PLANNING BOARD MEETING MINUTES

December 21, 2021 – 6pm
Village Hall, 10004 New Town Road
Regular Meeting (Virtual Meeting)

2. Discuss and Consider Recommendation of the Estates at Marvin Branch Preliminary Plat and Construction Plans (See attached, Item 2, which is included as a reference in these minutes).

For Estato Comments - send Email

STORM DRAINAGE PLAN
 C-3.1

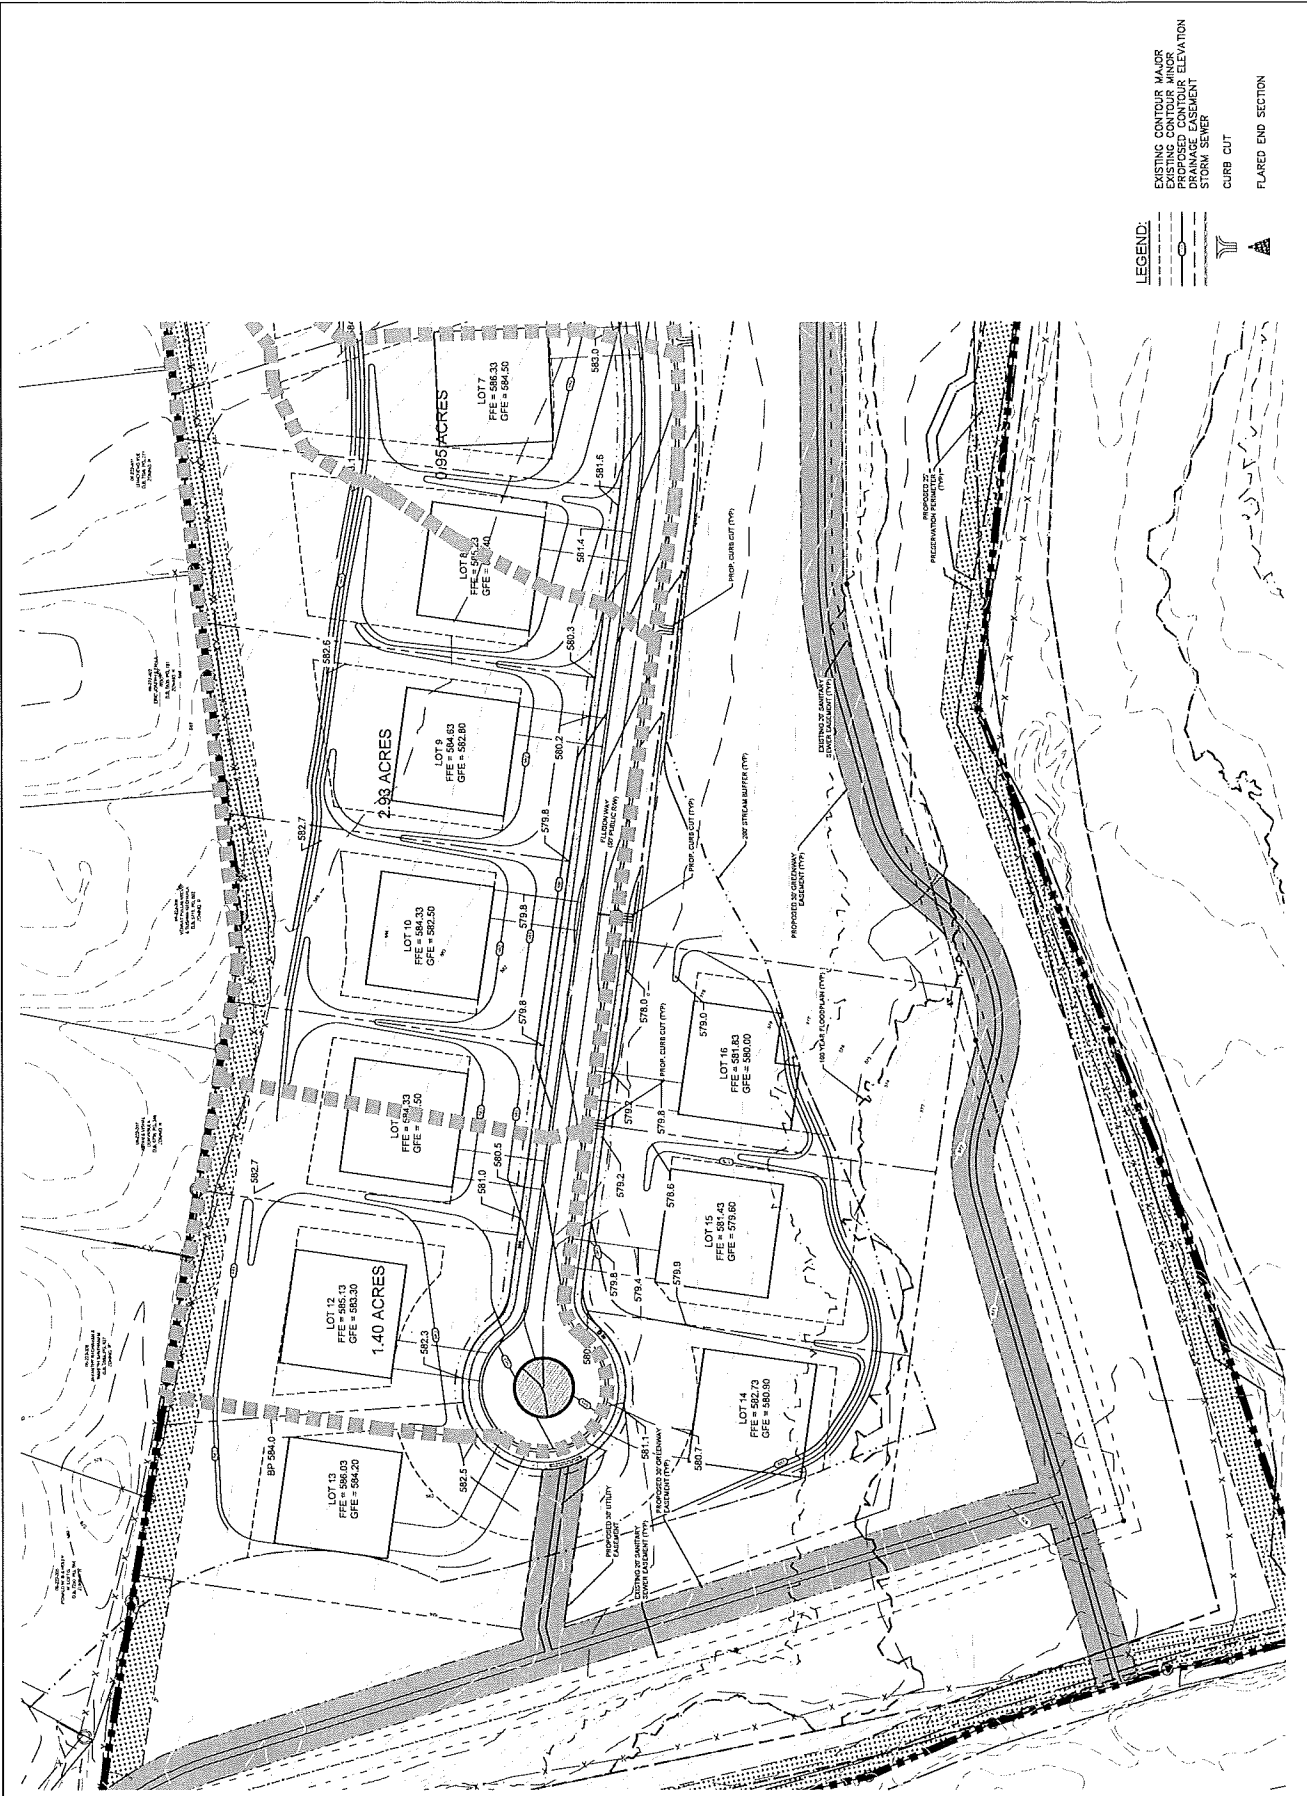
2. The drainage areas for CC#1 through CC#4 need to extend onto the adjacent properties behind the proposed lots as the contours clearly show runoff being sent toward this development.

3. The drainage areas for CC#5 through CC#10 appear to extend too far and can be reduced based on the contours shown.
4. The design calls for drainage swales to convey runoff from the road through channels to the stream buffer. There is no provision made for erosion protection within the swale or at the end of the swale to diffuse the flow before entering the stream buffer.

5. The plan shows the anticipated flow rate for each swale but does not provide the calculation identifying how the flow rate was derived.
6. While not a stormwater comment, the plan shows the greenway running roughly parallel with the stream so each drainage swale will cross it but no provisions to convey the water over or under the greenway, likely resulting in erosion issues with the greenway.
